Brookline Preservation Commission

Local Historic District Report

Local Historic District: Cottage Farm

Applicant: The Children's Hospital, Inc.

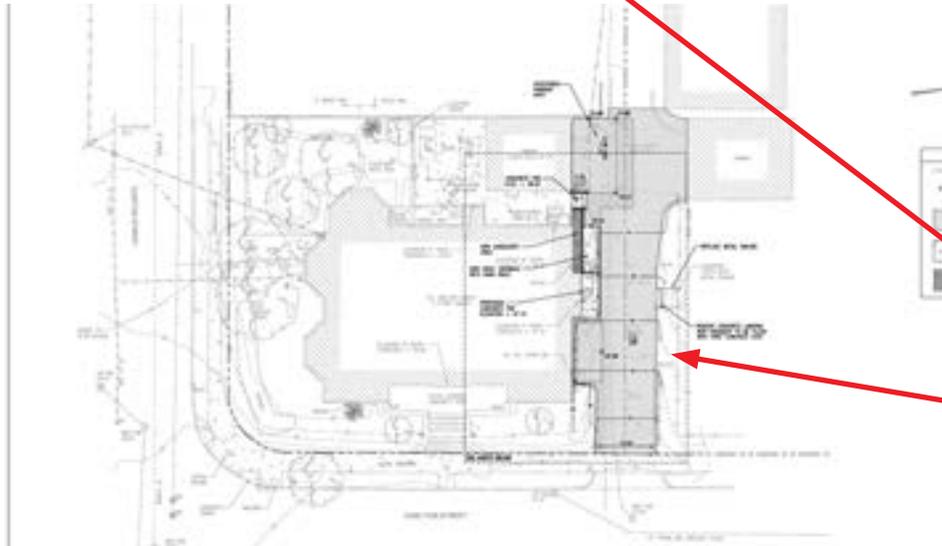
Preliminary Findings: Because this is a corner lot and the property line has street frontage, the proposed six foot brick wall, especially in front of the house, exceeds the 42 inches. Because this is a stucco house with an existing stucco wall in the rear, a stucco wall might be more appropriate than brick. The retaining walls and parking space do not seem incongruous.
